SUBJECT: GRAND GULF NUCLEAR STATION, UNIT 1 - ISSUANCE OF AMENDMENT
RE: IMPLEMENTATION OF ALTERNATE SOURCE TERM LIMITED SCOPE
APPLICATION FOR THE TIMING OF THE ONSET OF GAP ACTIVITY
RELEASE (TAC NO. MA4252)

Amendment No. 143
License No. NPF-29

SAFETY EVALUATION BY THE OFFICE OF NUCLEAR REACTOR REGULATION
RELATED TO AMENDMENT NO. 143 TO FACILITY OPERATING LICENSE NO. NPF-29

GRAND GULF NUCLEAR STATION, UNIT 1

Figure 1 Core Average Axial Power Distribution Used in TRAC-BF1 Analysis

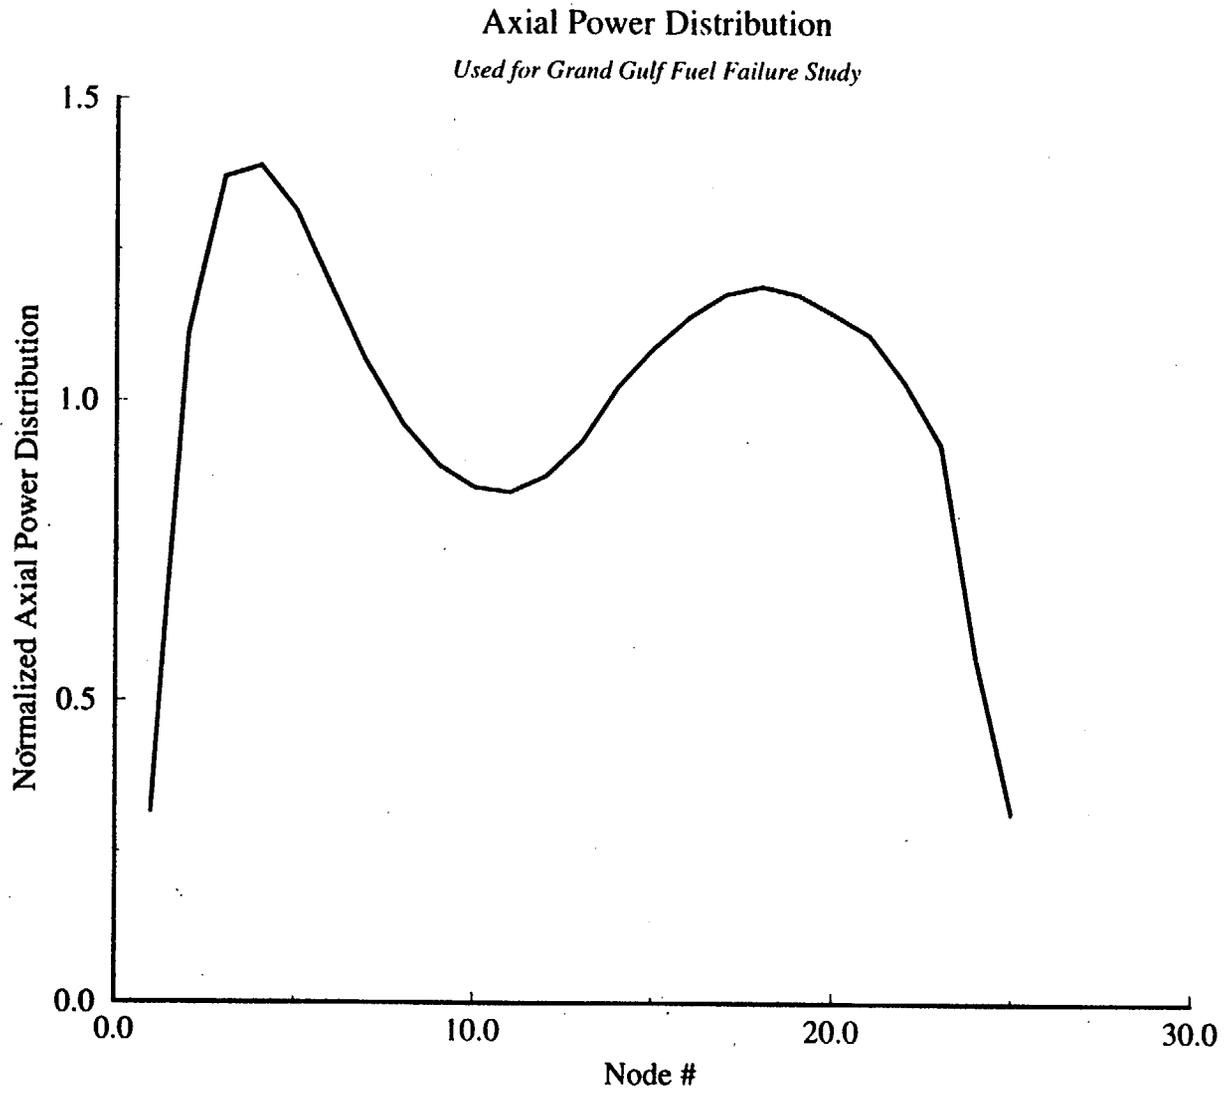
The staff obtained a GGNS input deck originally prepared by INEEL. This deck was written for a previous version of the TRAC computer code and, therefore, had to be modified to run with the BF1 version of TRAC. All of the plant geometry was retained with the exception of the jet pumps. The staff used a jet pump model, which was extracted from another BWR/6 input deck, and changed the number of jet pumps to correspond to the number at GGNS. The deck consists of 46 components. The major parameters used in the deck are given in Table 1. The staff used information from the most recent core operating limit's report dated August 13, 1997 (Reference 6), to determine the fuel type being used at GGNS, and used the staff's lattice physics methods to predict radial peaking factors for use in the CHAN component type. The part length fuel rods were not modeled and the internal water channels were modeled with water pins. The axial power distribution is shown in Figure 1 and the remaining kinetics parameters were taken to be the default values.

Figure 2 TRAC-BF1 Predicted Peak Cladding Temperatures for Grand Gulf Design Basis LOCA with no ECC Injection

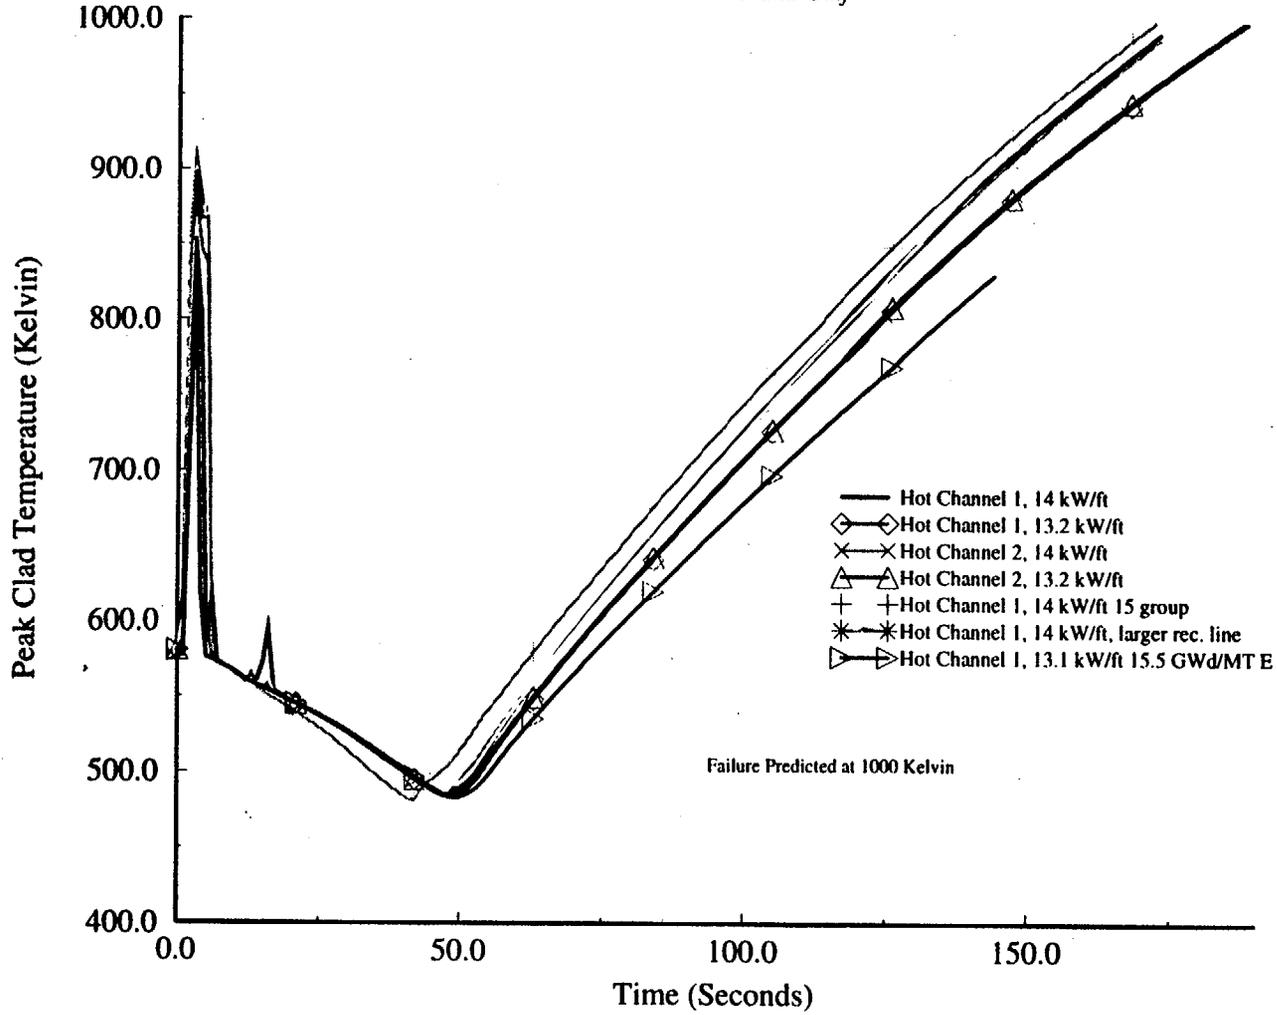
The PCT as a function of time is presented in Figure 2. As shown in the figure, the minimum time to failure is estimated to be 172 seconds. In order to confirm that the model is behaving as expected, the staff also examined the steam dome pressure (Figure 3) and the break flows (Figure 4), and confirmed that the ECCS injection flows were zero by examining the computer output file.

The plant-specific calculation results for GGNS demonstrate a conservative upper bound for the minimum time to the onset of gap activity release. On the basis of this evaluation, the licensee's request to revise the GGNS UFSAR to change the minimum time to the onset of fission product release from perforated fuel rods following a postulated design-basis accident to 121 seconds from the currently specified instantaneous release is acceptable.
